Engineering has reviewed the plans for the Woodlands Landing at Echo Farms-Tract 3A project submitted April 24, 2019 and have the following comments:

Woodlands Landing Tract 3A (Wet Pond 3A-2)

Pond 3A-3 Routing Peak Elev:

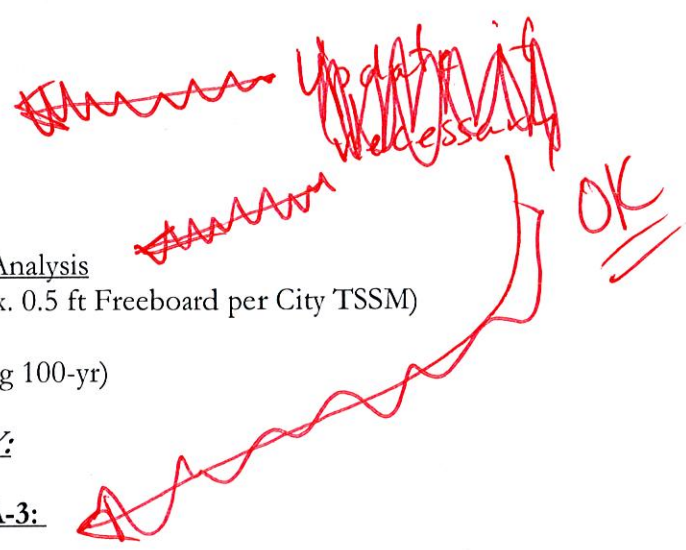
Update: total pervious cover equals 7.37 ac.
